No. 2021/3/CE-III/BR/1/CBEs Seminar

Sub:-CBEs Seminar held on 02nd & 03rd December, 2021 at IRICEN/Pune.

DISCUSSION ON AGENDA ITEMS FOR CHIEF BRIDGE ENGINEERS SEMINAR HELD AT IRICEN/PUNE ON
02nd & 03rd DECEMBER, 2021

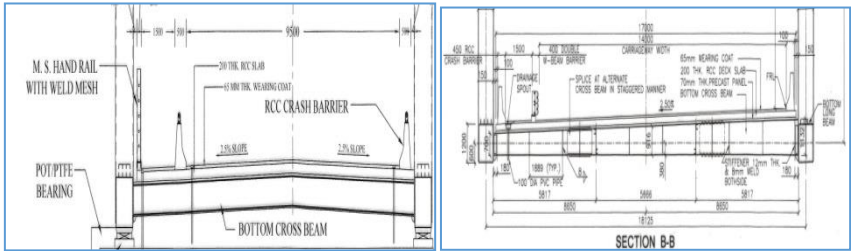
Poor-quality elastomeric bearings/ (or requiring design modification are being provided) in newly constructed bridges which are tested and passed at manufacturers labs. During commissioning stage only, bulging to different extent is generally seen in elastomeric bearing of composite girder due to self-weight & super imposed dead load (Ballast, Sleeper & track). Guideline/parameter not mentioned about limiting case of bulging of elastomeric bearing. Criteria for rejection of bearing due to bulging should be clearly defined.

A case in point- Br. No 313 is newly constructed bridge under SANKI- TATISILWAI section of Dhanbad division of E C Railway. In this bridge, there are 32 nos. elastomeric bearing. But due to dead load only, bulging and crack in 22 nos. elastomeric bearings occurred bulge and crack as shown

<p>in fig. below.</p> 	
8.	ECR	<p><u>Bow String Girder</u> – Guidelines required in Indian Railway Bridge Manual for inspection and maintenance of Bow String Girders as ROB with BOW string girder is increasing day by day. Inspection/maintenance of top chord is not possible due to curved profile, hence arrangement for inspection/maintenance should also be included in RDSO drawing. Arrangement for inspection of bottom cross beam & its connection with bottom long beam is also required in RDSO drawing. Further fabrication/erection tolerance for various members of Bow String Girder may also be spelt out in IRS-B1-2001(Specification for fabrication and erection of steel girder bridges & Locomotive Turn Table).</p>	<p>The item of inspection was deliberated in 86th BSC and Inspection arrangement was finalized. Feedback from various railways was required so as to finalize scheme by RDSO.</p> <p>Feedback from Railways shall be provided by 31.01.2022.</p>

IRC 83 pt II Clause 3.4.4 will be examined by RDSO.
